**DOMINION VIRGINIA POWER**  
**NORTH ANNA UNIT 3 COMBINED LICENSE APPLICATION**  
**ESRP 2.4.1, 3.1: RESPONSE TO ER RAI LETTER**

**RAI NO.: ENV-01 (RAI LETTER DATED FEBRUARY 1, 2013)**

**ESRP SECTION: 3.1- EXTERNAL APPEARANCE AND PLANT LAYOUT**

NA3 AREA  
TE-01-A

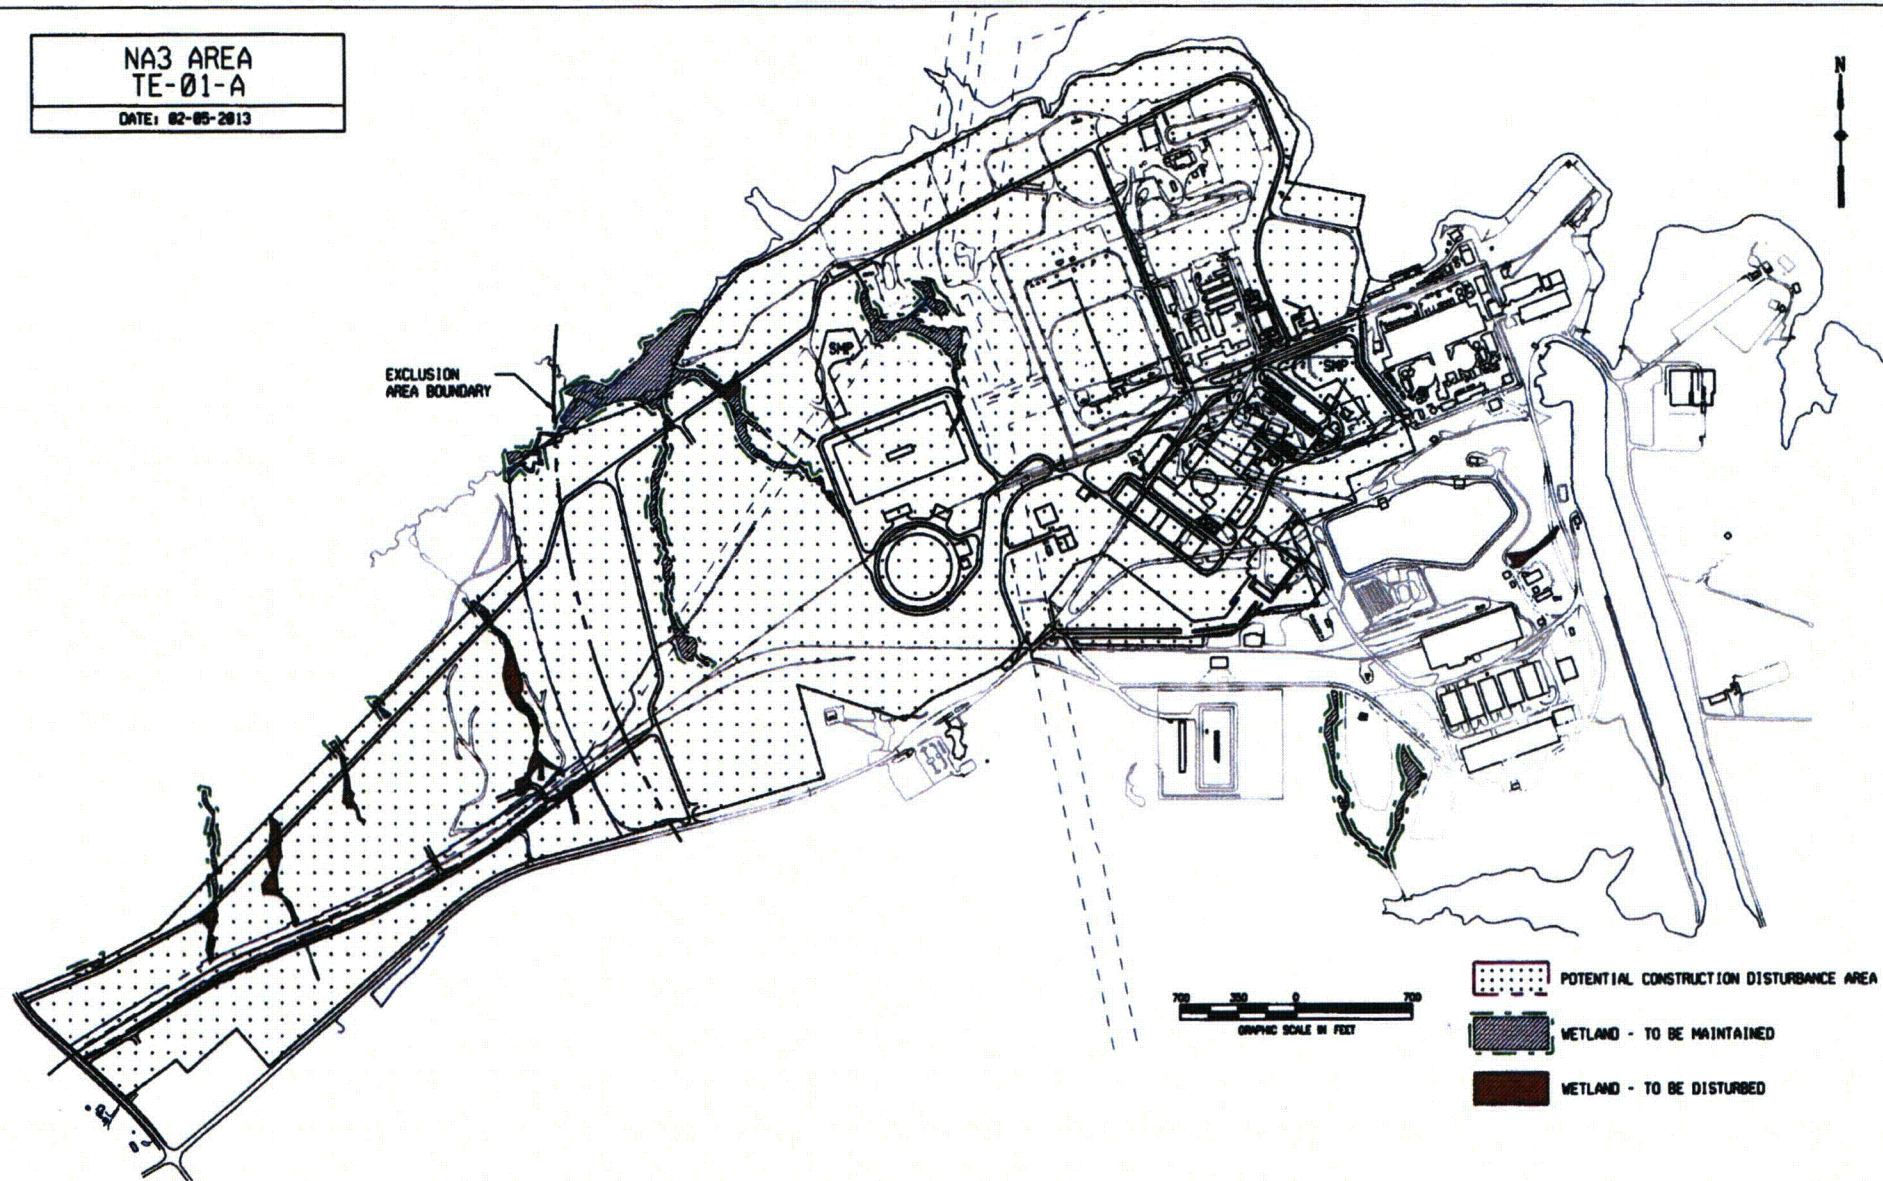
To facilitate both the Section 7 Consultation (Endangered Species Act) with USFWS and the project description in the supplement to the COL FSEIS, provide figure(s)/map(s) that show the following:

- the potential area of ground disturbance related to building and operating Unit 3,
- potential habitats within the disturbance footprint, and
- biotic survey locations.

Two figures, labeled as "TE-01-A" and "TE-01-B," are provided to address question TE-01. The source files are vector-derived portable document format (pdf).
